Addendum 3

Client: Creswell School District
Project: CHS Academic Building Improvements (Primary) Project
Date: March 11, 2026
To: Interested Bidder
Prepared by: Curt Wilson, AIA; Principal, Wilson Architecture

This Addendum modifies the Project Manual, Specifications, and Drawings as follows:

1 ROOF PLAN - AREA A
A1.21 1/8" = 1'-0"

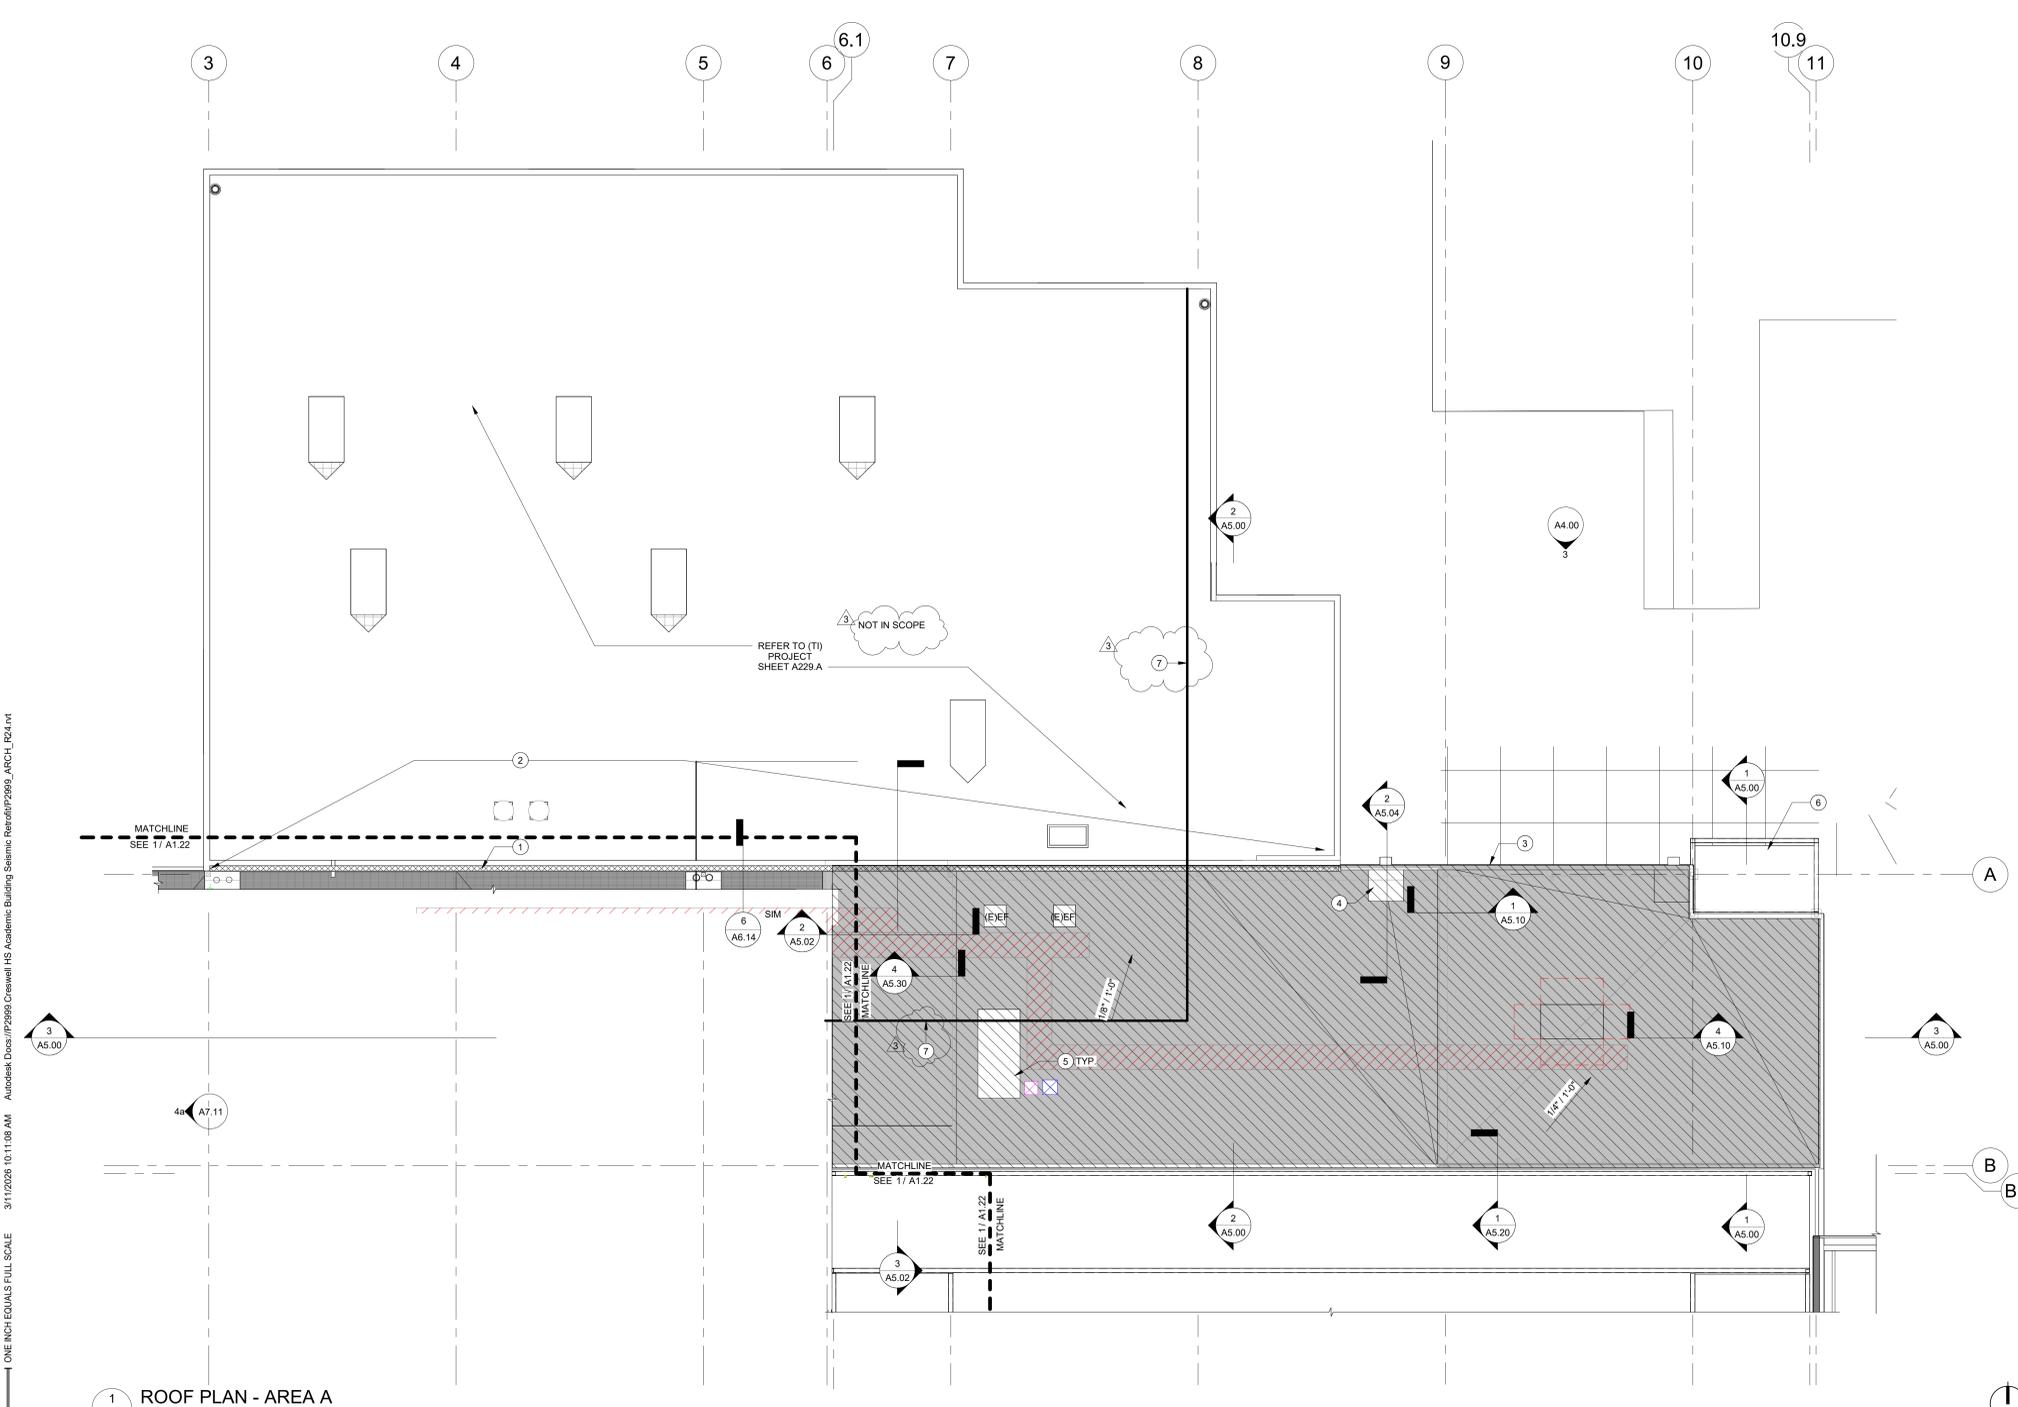
- Size of door in Room 224 adjusted to 42 inches wide. Note, door number changed to 224.1.
- 3.5. Sheet A1.21 – Roof Plan – Area A
- a. Replace original sheet with attached version. A brief summary of the changes include:

- Notes about existing conduit added to the drawing.
 - Note added to clarify the reroof over the 2003 Addition is not in the scope for the Primary Project.

1 ROOF PLAN - AREA B
A1.22 1/8" = 1'-0"

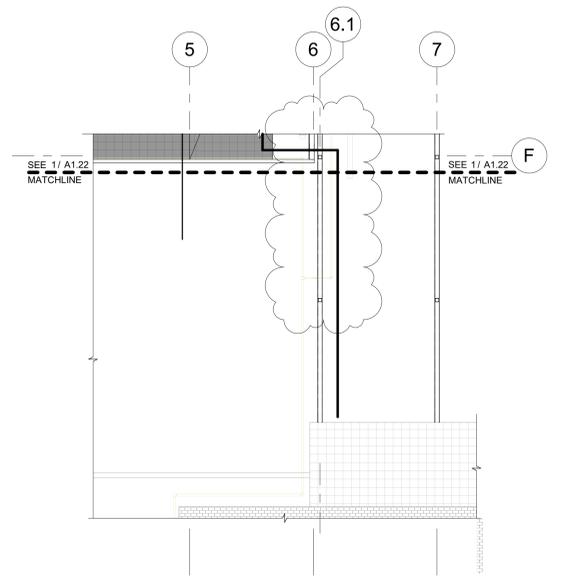
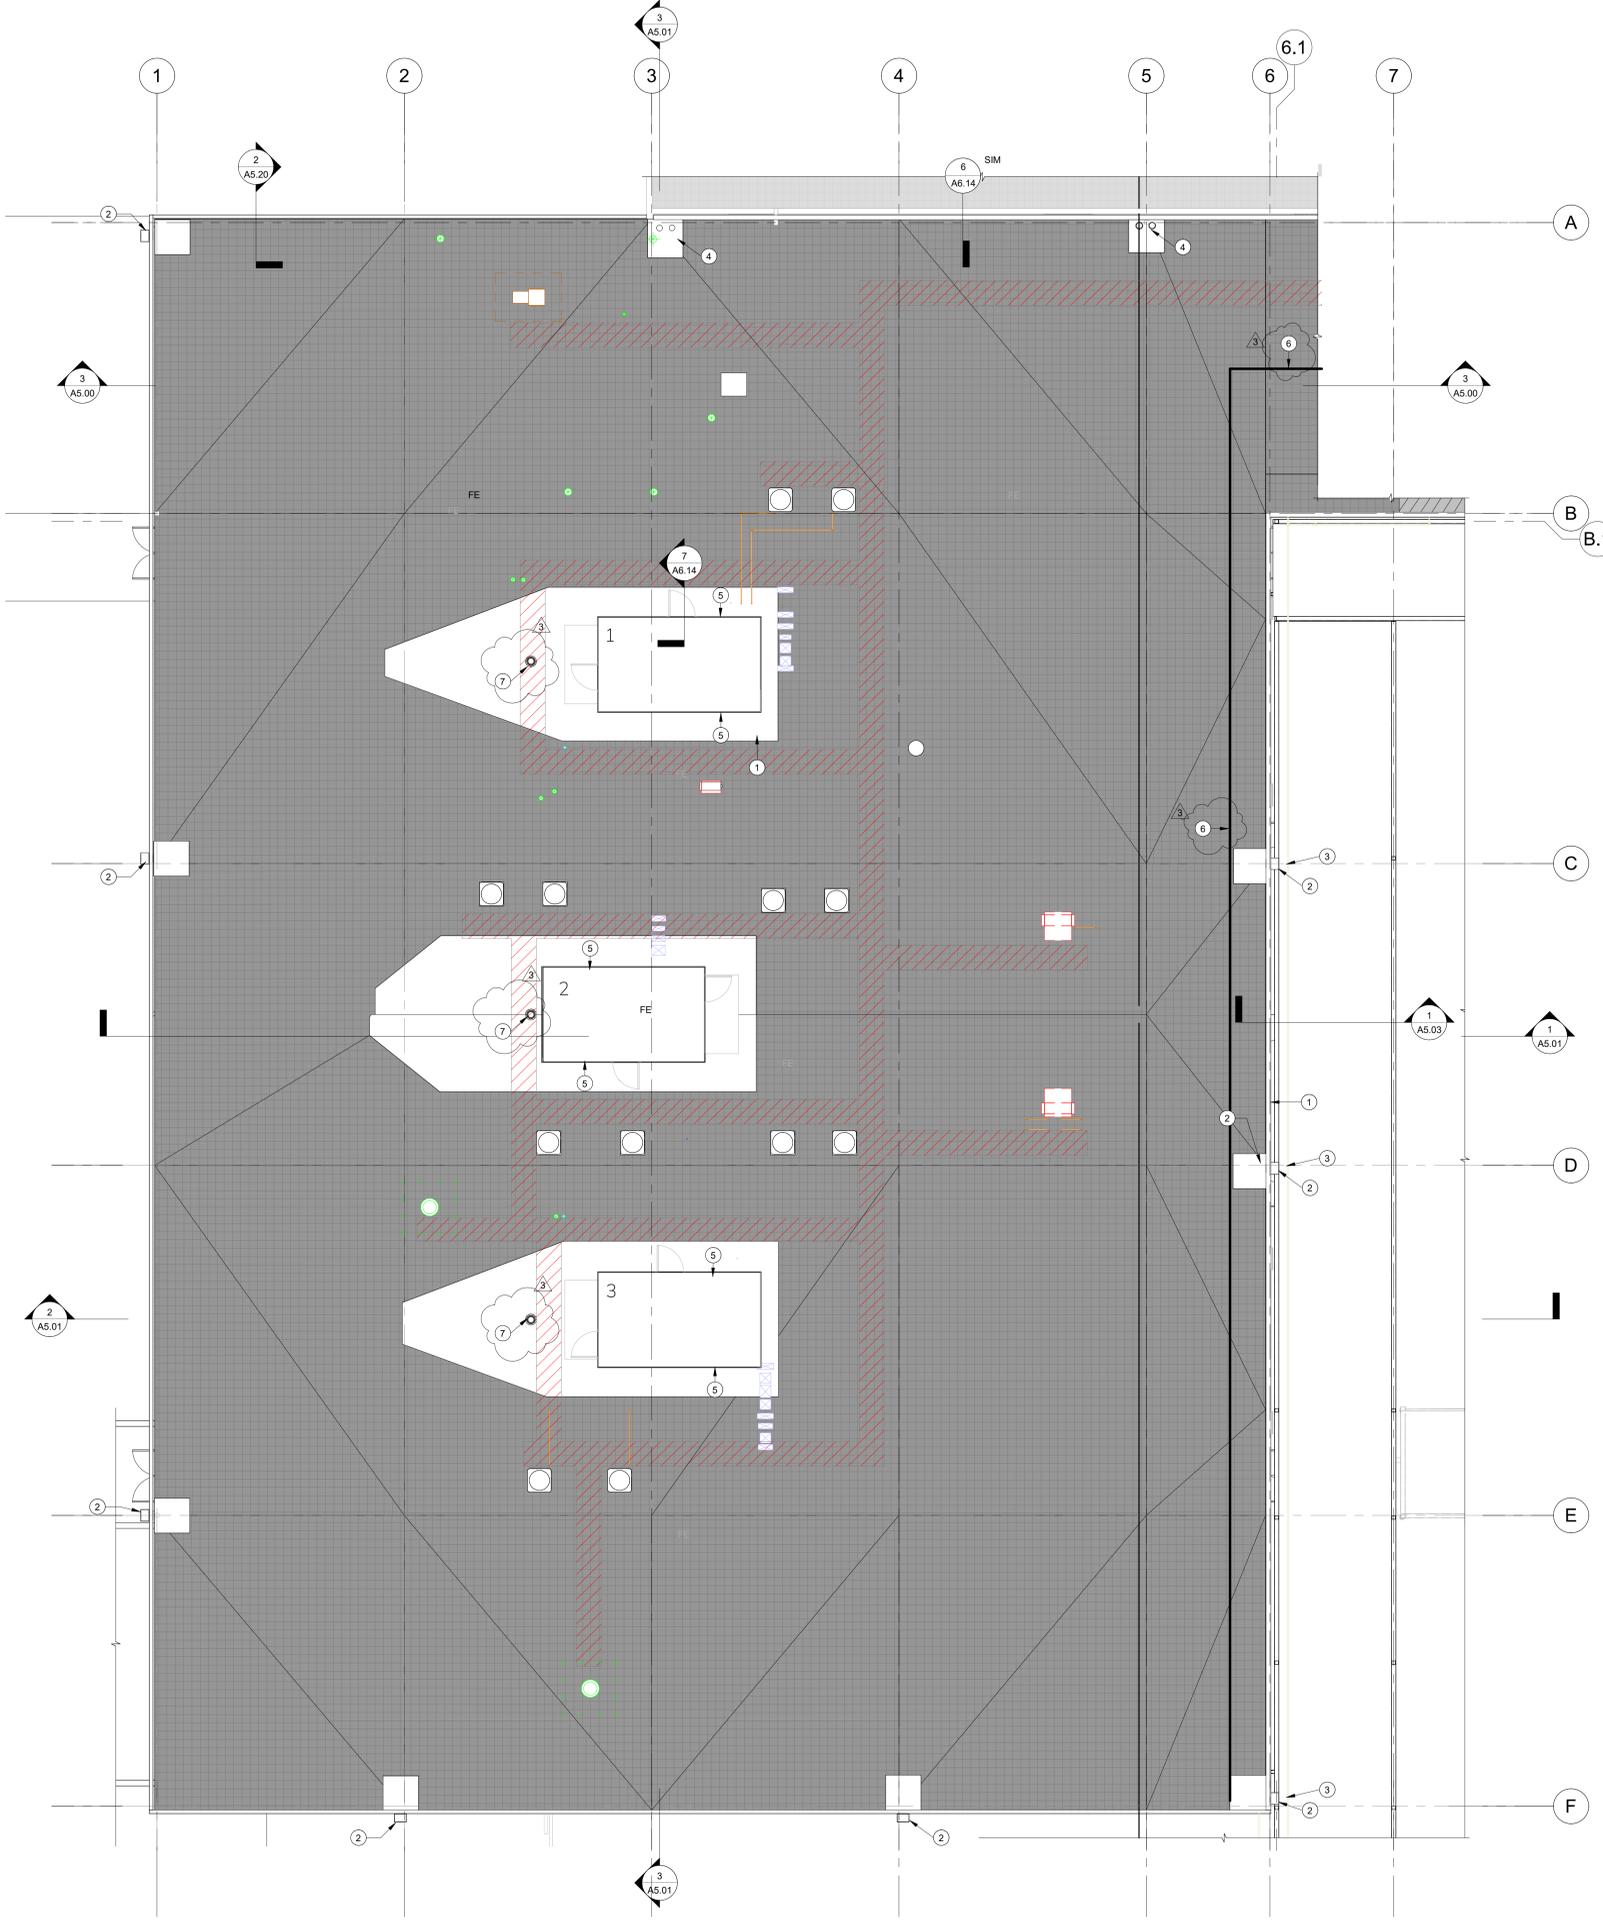
- 3.6. Sheet A1.22 – Roof plan Area B and C
- a. Replace original sheet with attached version. A brief summary of the changes include:
- Add overflow roof drains at recessed areas around existing HVAC Dog House units.

1 EAST ELEVATION - AREA A
A4.00' 1/4" = 1'-0"

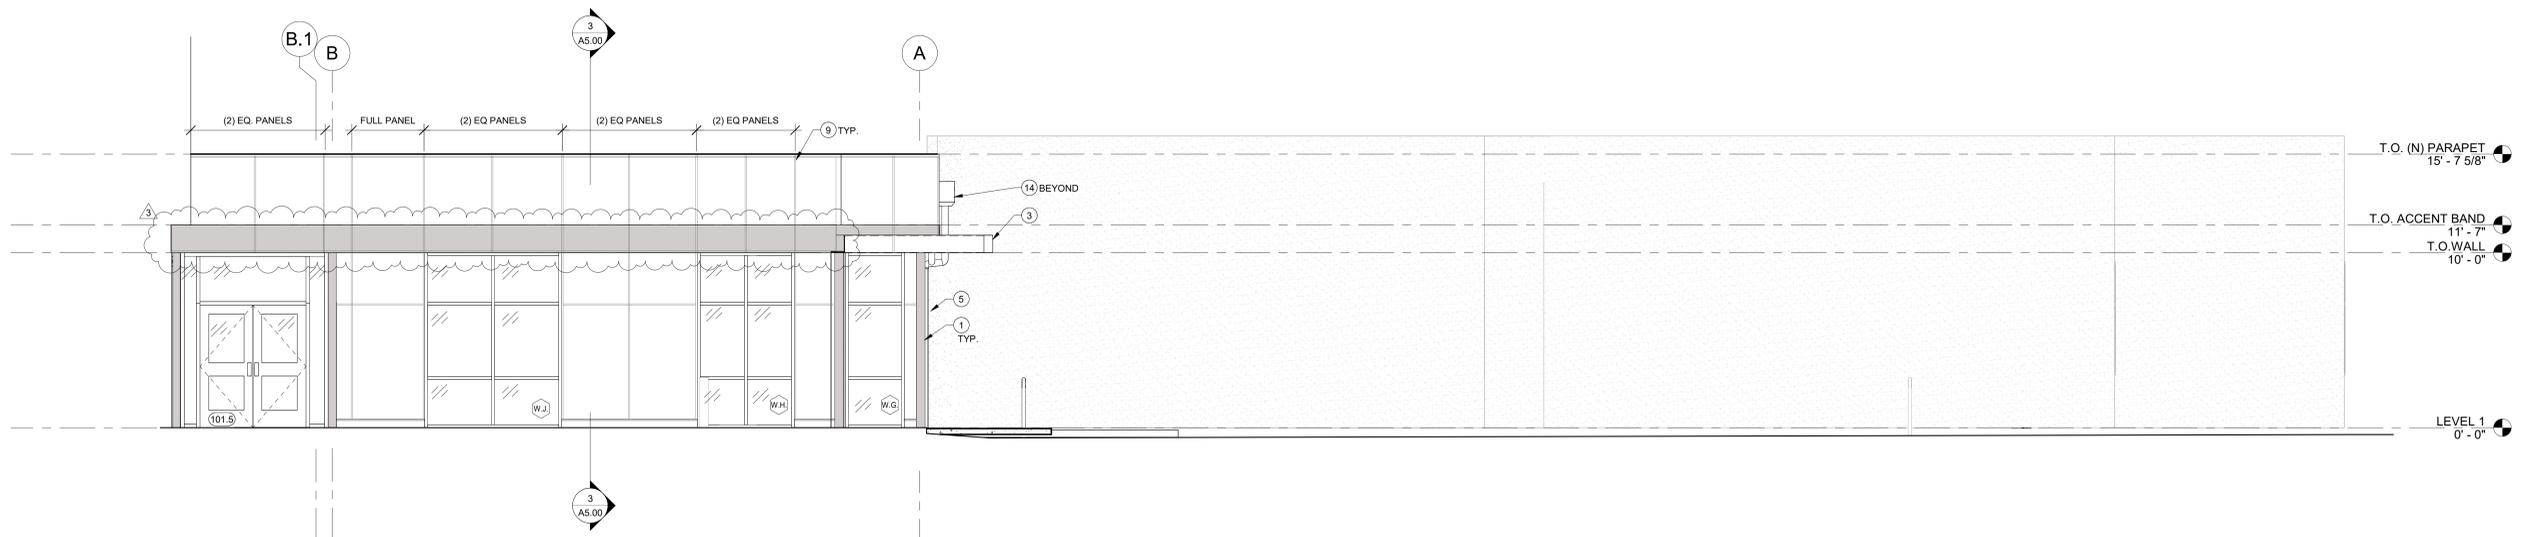
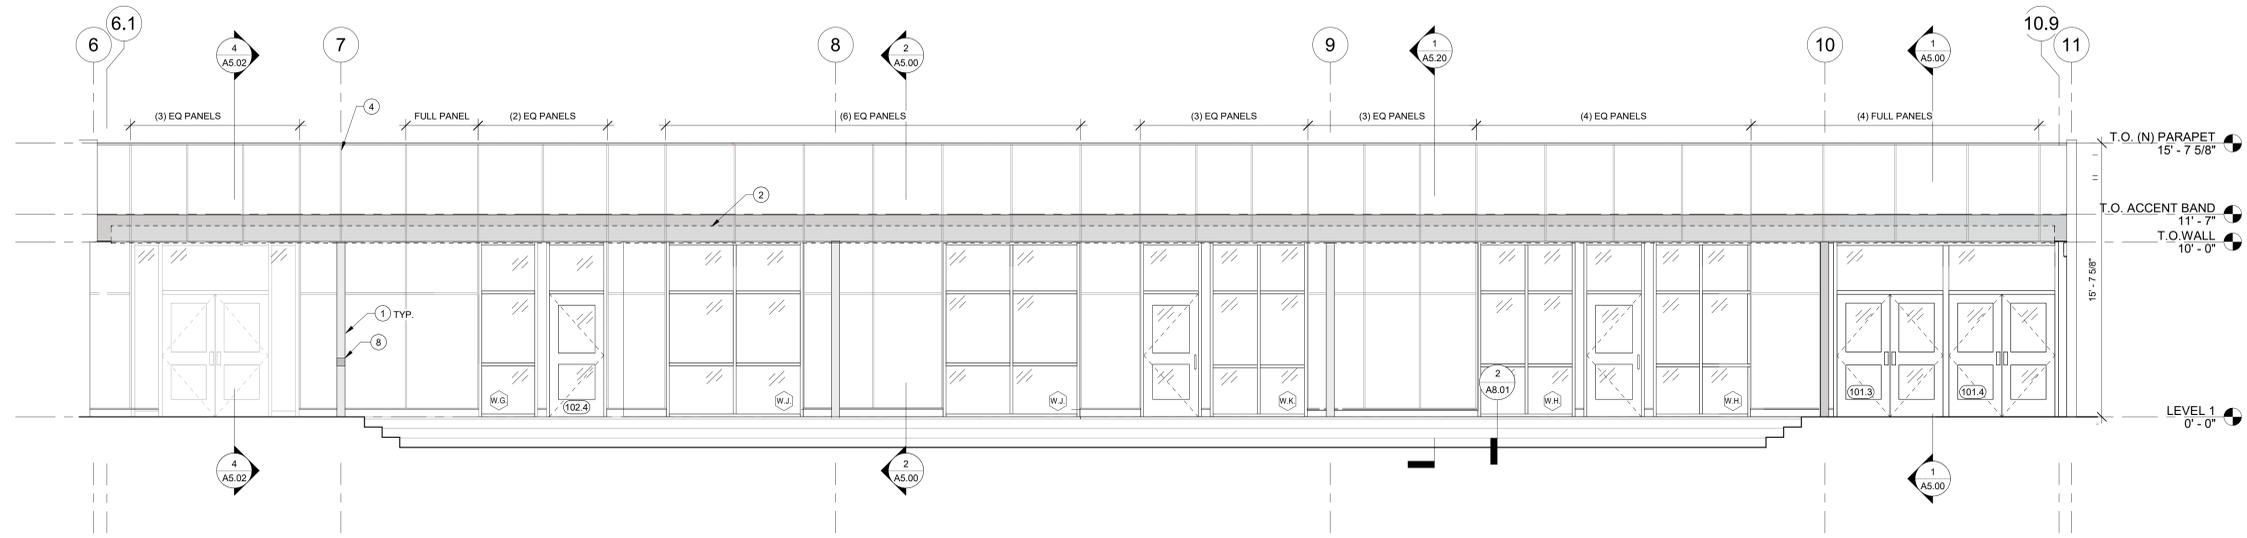
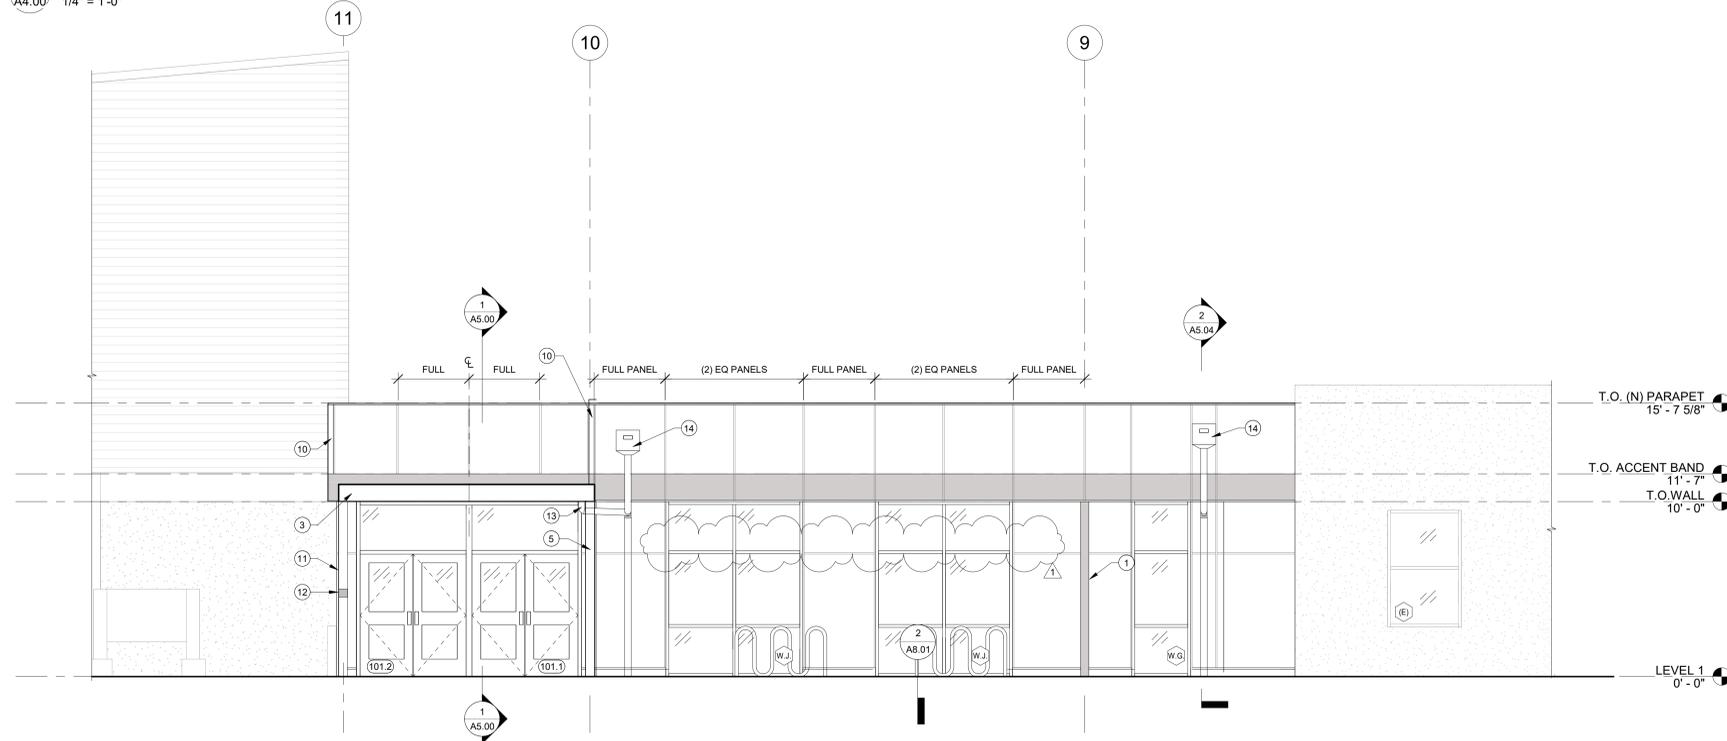
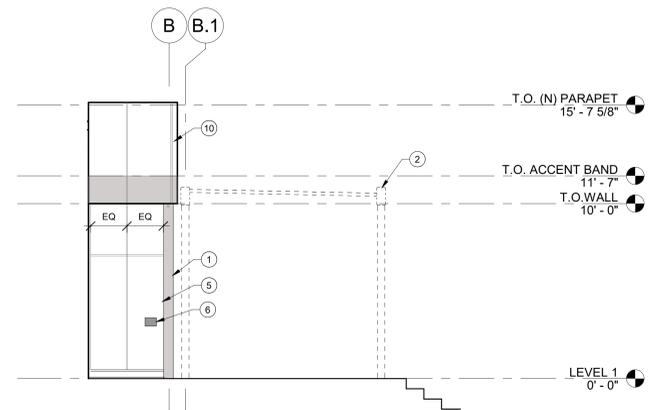
- 3.8. Sheet A4.00 – Exterior Elevations
- a. Replace original sheet with attached version. A brief summary of the changes include:
- The revisions clarify the extent of the accent band in the siding.
